CITY OF PORTLAND, MAINE

AGENDA PORTLAND PLANNING BOARD MEETING

To: Chair Stanley & Members of the Planning Board
From: Austen Torres Davis
Date: April 22, 2022
Re: 7 Marion Street – Major Site Plan
Project ID: PL-001894-2022
CBL: 012 Po27001
Meeting Date: April 26, 2022

Subject: Site Plan Review Comments – 7 Marion Street

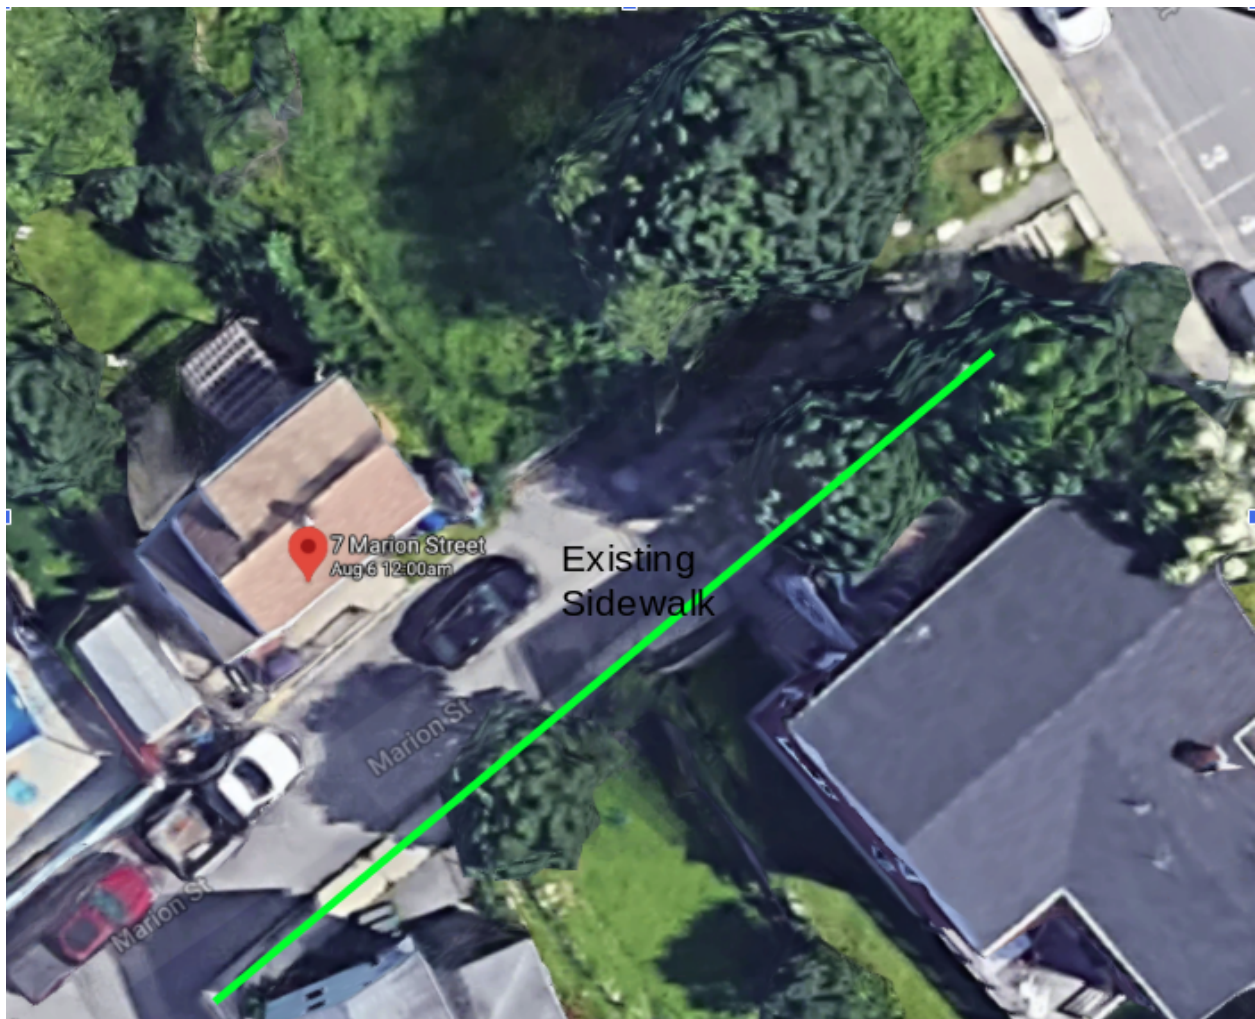
The proposed structure will have a 0' setback from the street. The section of road is a dead end with minimal traffic. There is an existing sidewalk on the right side of the street. The sidewalk goes up the right side of the street. There is no sidewalk on the left side of the St. even before the dead end.

A.

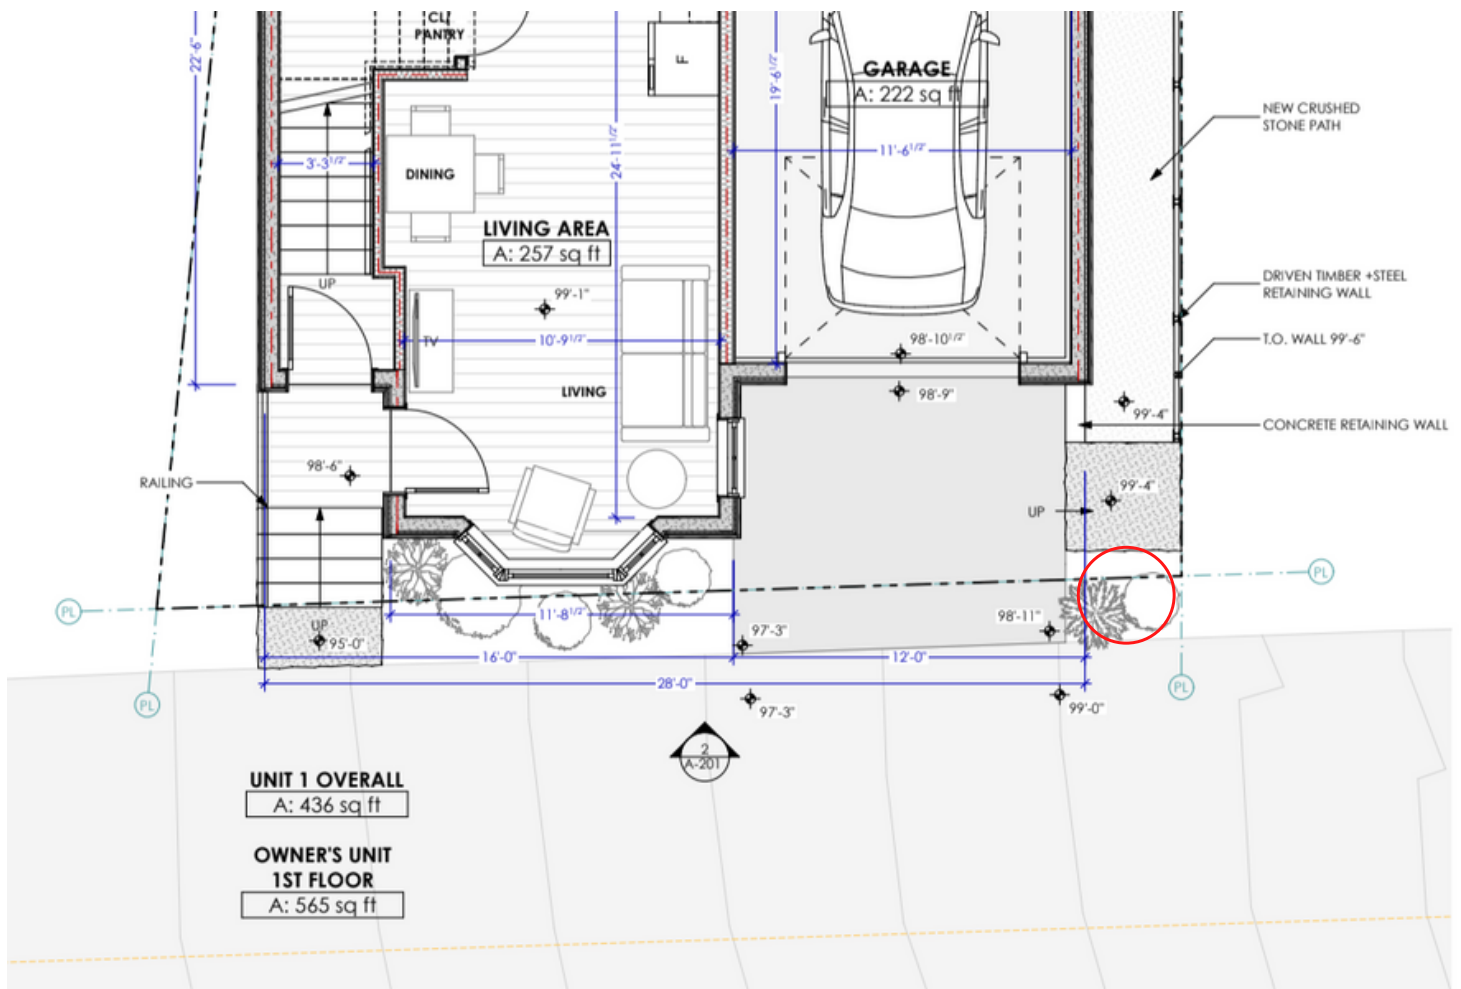
There is potentially room for one tree, location in the red circle in figure A.

First Floor Plan Comments

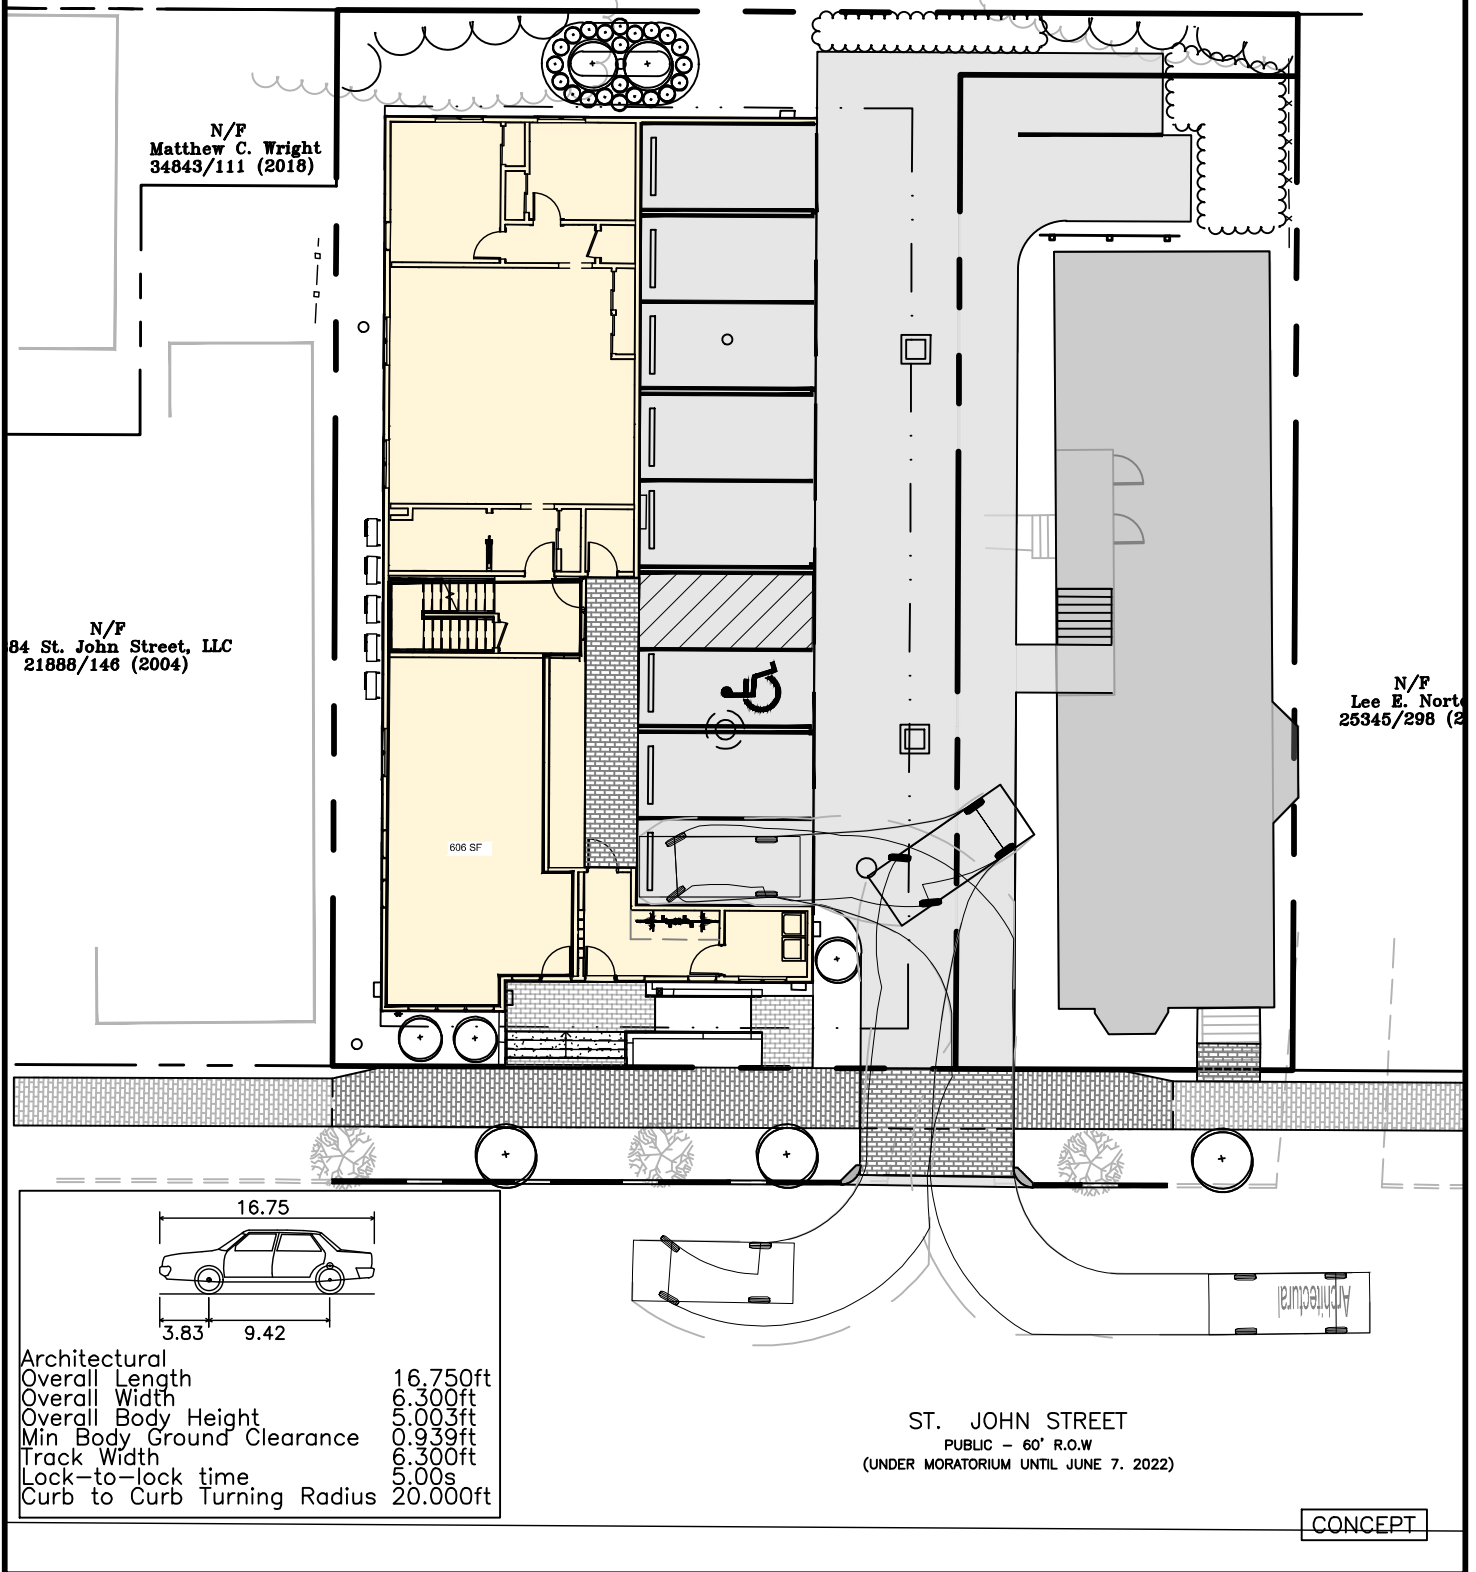
- Parking space: ADA space is between column lines E and D. There is no column obstructing this space. See comments under circulation on page 1.
- Door: The door has also been relocated adjacent to the walkway.
- Bathroom: Note the dashed fixture clearances on plan illustrating compliance. -Turning radius: There are 5'-0" turning radius at bottom and top of ramp.
- Rail: There are handrails on both ramp and stair which include 1'-0" rail extensions at top and bottom per code outside the turning radius.
- Mechanical exhaust: Mechanical engineer will confirm compliance with exhaust standards.
- EV charger placement: EV charger is placed adjacent to the access aisle to prevent non-compliance with amenities provided for accessible spaces inaccessible spaces.
- Basement: No tenant amenities in basement just building sprinkler riser.

Thanks for your feedback.
